Office Action Summary

10/803,730

BUSAM ET AL.

DETAILED ACTION

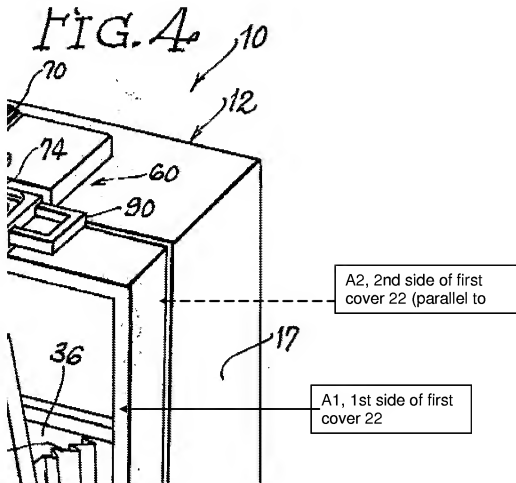
7. Claim 51, as best understood, is rejected under 35 U.S.C. 102(b) as being anticipated by Malooly (USP 3,912,055).

MALOOLY teaches a first generally planar cover/component (22) pivotally coupled to a second generally planar cover/component (12), both of said covers being generally flat and planar; said first cover/component including an opening (36) and having a first side (A1) and a second side (A2 being parallel to A1: see figure below); and a pocket coupled to said first planar cover/component and generally received in said opening, said pocket including a front/first panel (26) and a second/rear panel (42) defining a pocket cavity there between, said first/front panel (26) being larger than said opening (see figures 1 and 4) and at least portions or tabs (54) of the second panel (42) extending outwardly/to the side beyond said opening (see figures 1-4 and col. 3, lines 5-20). Furthermore, regarding claim 22, MALOOLY teaches the second panel (42) is preferably provided with stop means to engage the ledges or stop elements (50), so as to prevent the second panel (42) from swinging out of the first cover (22) ('055, col. 3, lines 7-10). Figure 1, shows the first/front panel (26) pivoting independently and figure 3 shows the second/rear panel (42) pivoting independently. MALOOLY also teaches a first releasable fastening mechanism (32) positioned to releasably join said first panel (26) and said first side of said first cover (22) (see figures 1 and 4). MALOOLY also teaches in figure 1, the pocket and its cavity being accessed from the outside and in figure 3, the pocket being accessed from the inside of the first cover. MALOOLY also teaches when the first panel fastening mechanism (32) is undone, the first/front panel (26) can be pivoted away from the front cover/component (22) to its position shown in figure 1 whereby this configuration, the first panel (26) pulls the side panels (46) and portions of the pocket and pocket cavity through the opening (36) of the front cover (22)

such that generally all of the pocket cavity is located on the first side (A1) of the first cover (22) and generally no portion of the pocket cavity is located on the second side (A2) of the first cover (22) thus, portions of the pocket and pocket cavity are pulled to the first side (A1) of the first cover (22) such that the pocket cavity can be accessed and components can be placed into and removed from the pocket /pocket cavity by a user without having to reach through or break a plane formed by the first cover (22).

Similarly, when it is desired to access the pocket from the second side (A2) of the first cover (22), the second panel (42) is pivoted inwardly (as shown in figure 3) thereby pulling portions of the side panels (46) and pocket cavity through the opening (36) such that in this manner, portions of the side panels (46) and pocket cavity are located on the second side (A2) and inwardly of the plane of the first cover (22) so that components can be added to or removed from the pocket cavity without a user having to reach to the first side (A1) or reach across or break the plane of the first cover (22). In this position, generally the entire pocket cavity is located on the second side (A2) of the first cover (22). Please note that, although MALOOLY is a suitcase and not a binder, Examiner stresses that it functions the same way as a binder which is to act as a means of storage thus reads on the claims. Furthermore, MALOOLY teaches said rear/second panel (42) being located on the inner side of the first cover/component while the front/rear panel (26) being located on the outer side of the first cover/component (see figures 3 & 4).
